**Evaluation of  
San Bernardino Valley  
Municipal Water District**

**THREE DAM PROPOSAL**

**Upper Santa Ana River & Mill Creek**

September 1982

SANTA ANA RIVER BASIN, CALIFORNIA
UPPER SANTA ANA RIVER AND MILL CREEK THREE DAM PROPOSAL
<b>CRAFTON DAM SITE PLAN</b>
US ARMY CORPS OF ENGINEERS LOS ANGELES DISTRICT

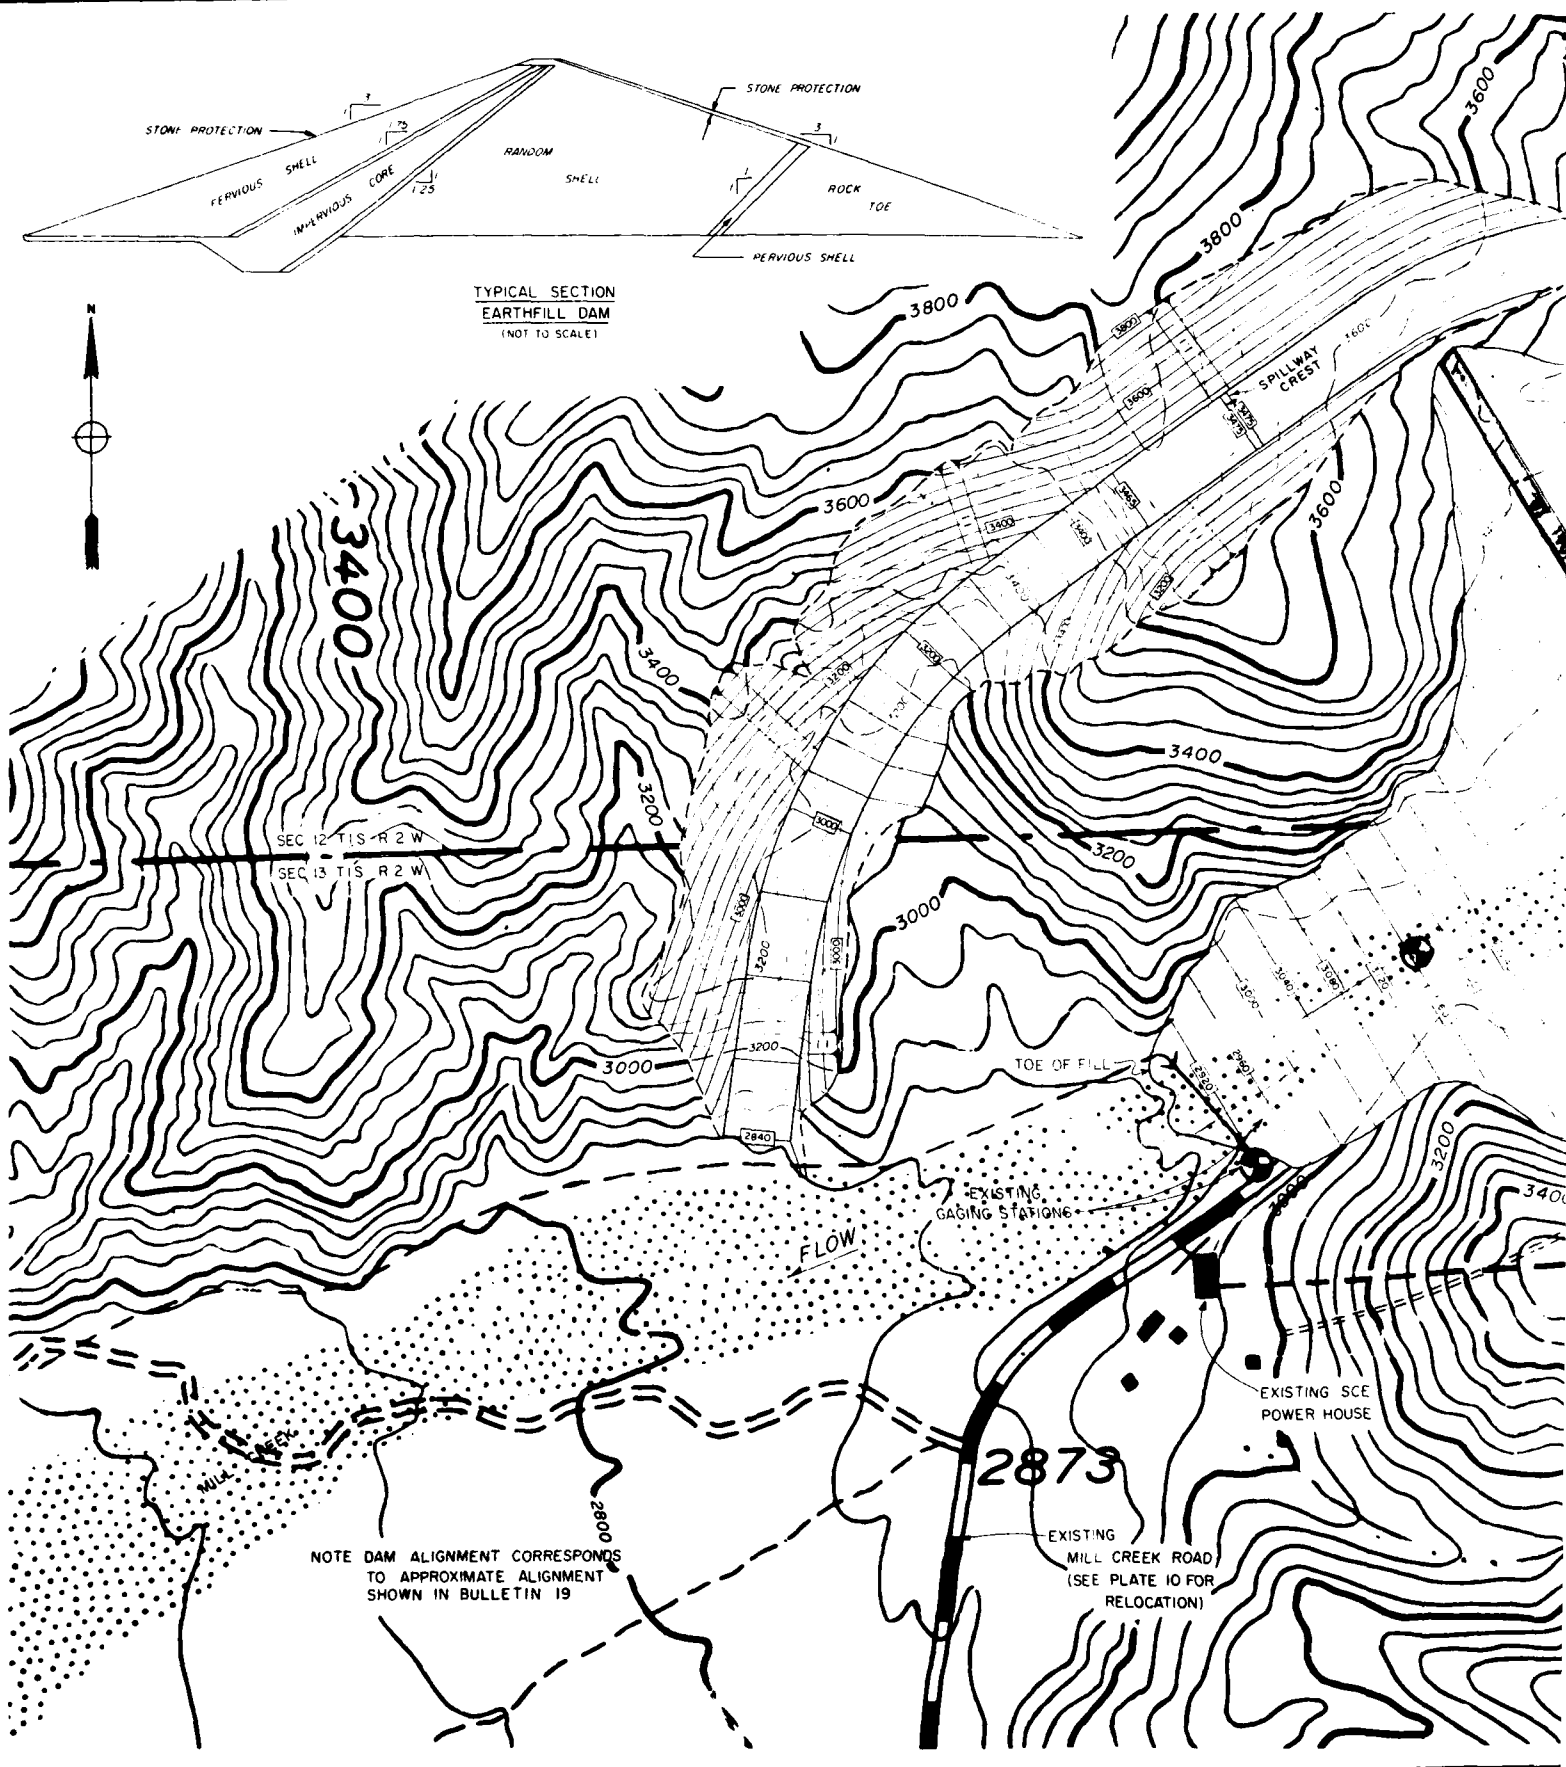
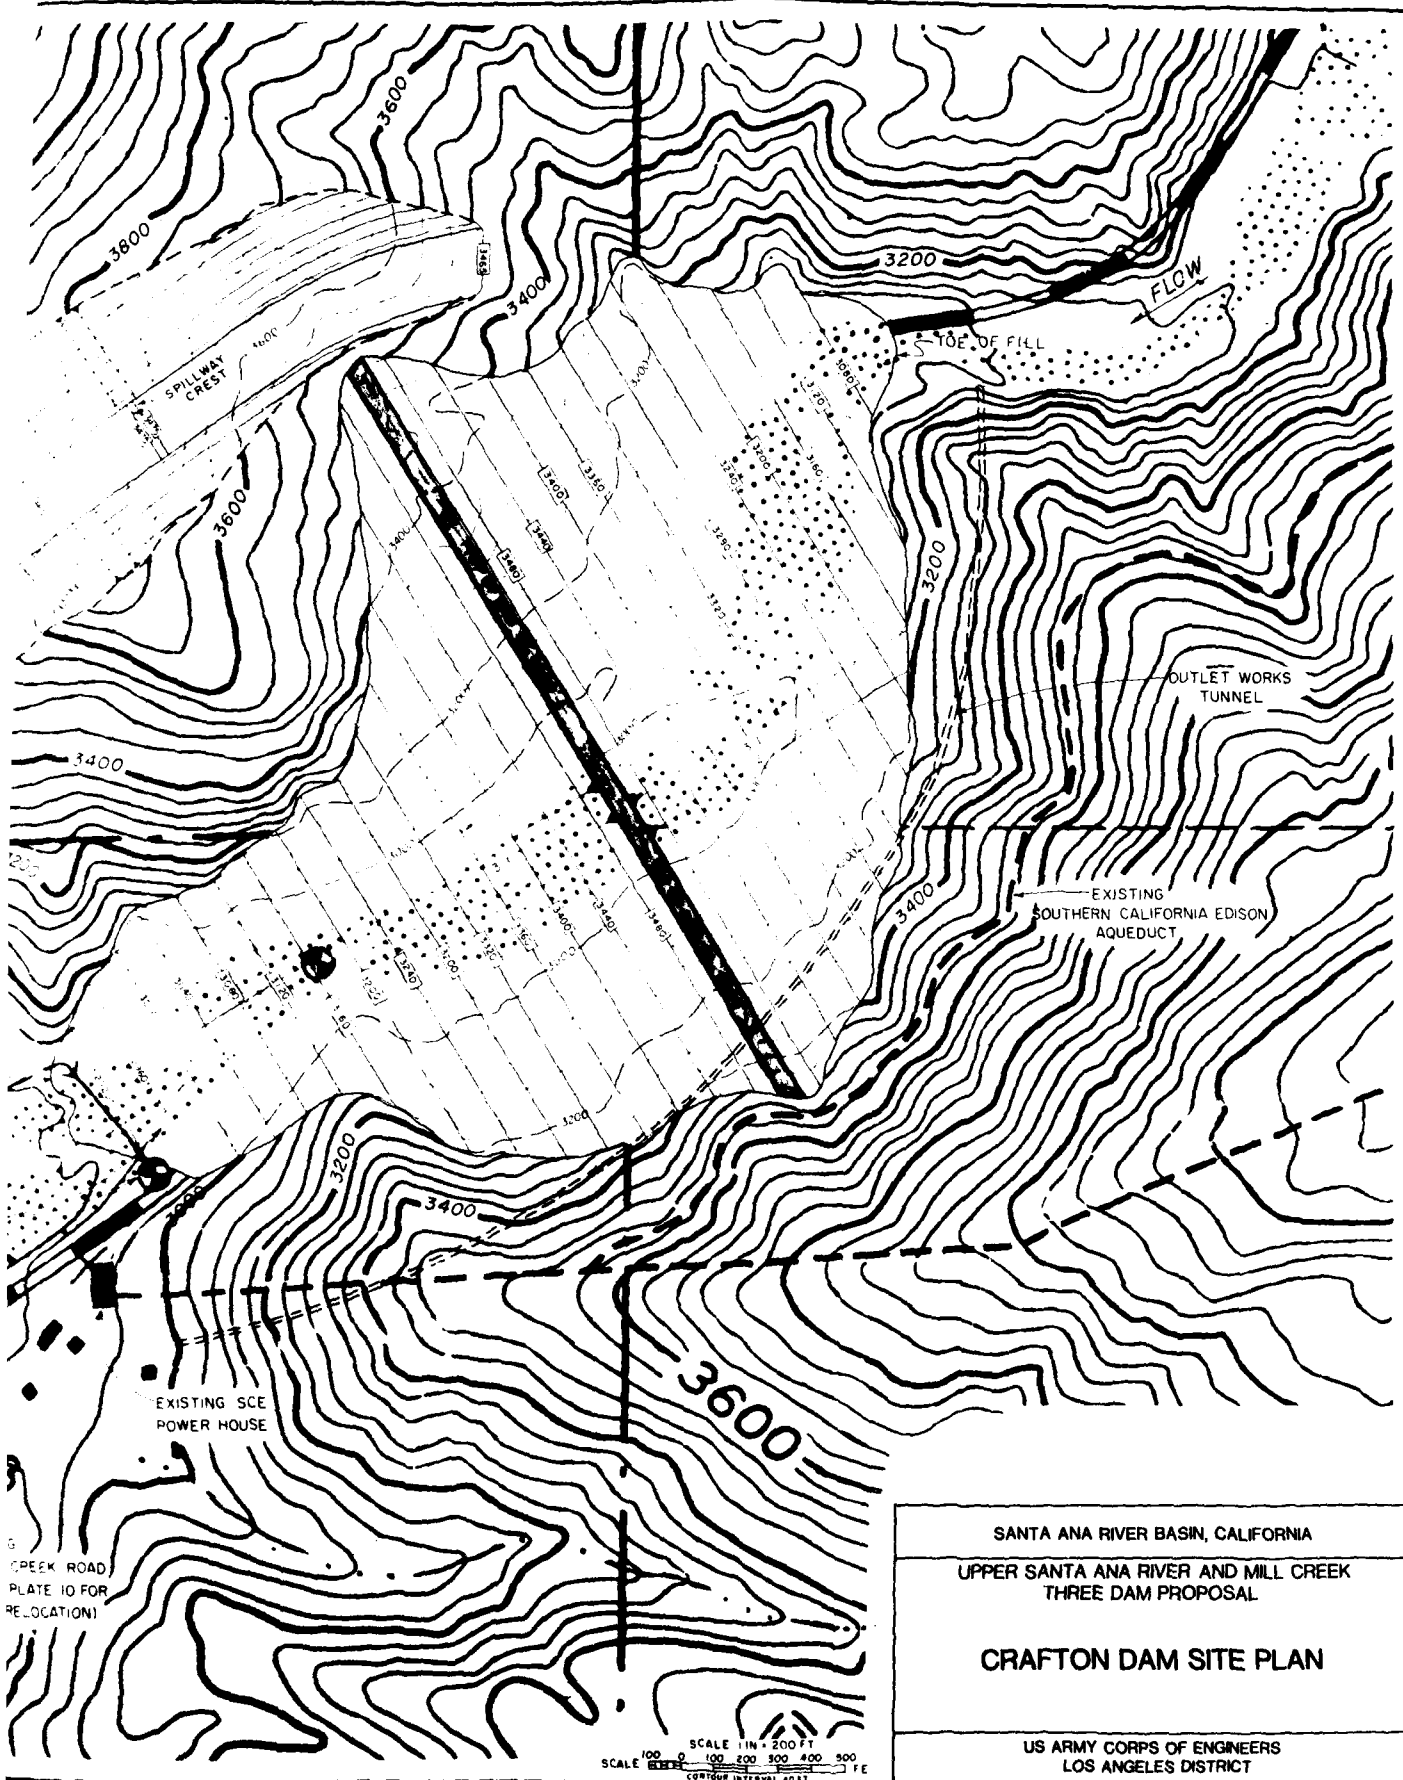
(3) Crafton Dam Site. This site is located as shown in Bulletin 19 at streambed elevation 2980. Applicability of the site for earthfill and concrete dams was considered. The canyon walls are moderately steep for a height up to 1600 feet above streambed, with bedrock consisting of interbedded sandstones and compressible shales. Streambed alluvium is estimated to be less than 100 feet deep and consists of coarse alluvium. An adverse dip of bedrock has caused a landslide in the west side accompanied by some seeping. The site is considered extremely marginal geologically for an earthfill structure because of the landslide and adversely dipping strata. It is unsuitable for concrete due to the presence of compressible shale layers in the abutments. When the slide is removed, future slides may recur and make the site unacceptable. Costs have been included in the estimate for landslide treatment, which includes slide removal. Sites immediately upstream exhibit similar topographic and geologic conditions. Locating the embankment upstream of streambed elevation 3040 would cause inundation of developments in Mountain Home village. An alignment further downstream would encroach on a Southern California Edison powerhouse and aqueduct, and increase quantity of fill for the embankment.

(a) Dam. A more suitable site, based on geotechnical, hydraulic and topographic considerations, could not be identified. The landslide in the west side makes this site extremely marginal for an embankment structure. Because of the compressible shale layers in the bedrock, the site is not suitable for concrete structures. See plate 9.

(b) Spillway. Both sides are relatively steep and undesirable as spillway sites. The west side was selected because it provides a more desirable downstream flow pattern in relation to the embankment, avoids impacting the Southern California Edison powerhouse downstream and is not as steep as the east side. The alignment and length of the spillway were selected to convey flow away from the embankment. The spillway would be concrete lined to protect the foundation from erosion and to provide more positive direction to spillway flow.

(c) Outlet Works. An outlet works alignment through the east abutment was selected as the most economical and one that permits minimum disturbance by spillway flow. A ten-foot diameter tunnel would be used for diversion and control of water during construction. Subsequently, the tunnel would be gated for flood control operation and incorporated with a hydropower outlet. Access to the gate chamber would be through a vertical tower and control house on the crest of the dam.

(d) Access Road. The existing Highway 38 would be relocated to the east bank of Mill Creek Canyon and over Crafton Dam to obtain sufficient length to meet maximum grade requirements. Design speed may have to be reduced from the existing limit. The relocated roadway would provide access to the dam and a bridge would be required near Mountain Home village to return the roadway to the west bank of the river. The total length of relocated roadway would be approximately 3.2 miles.
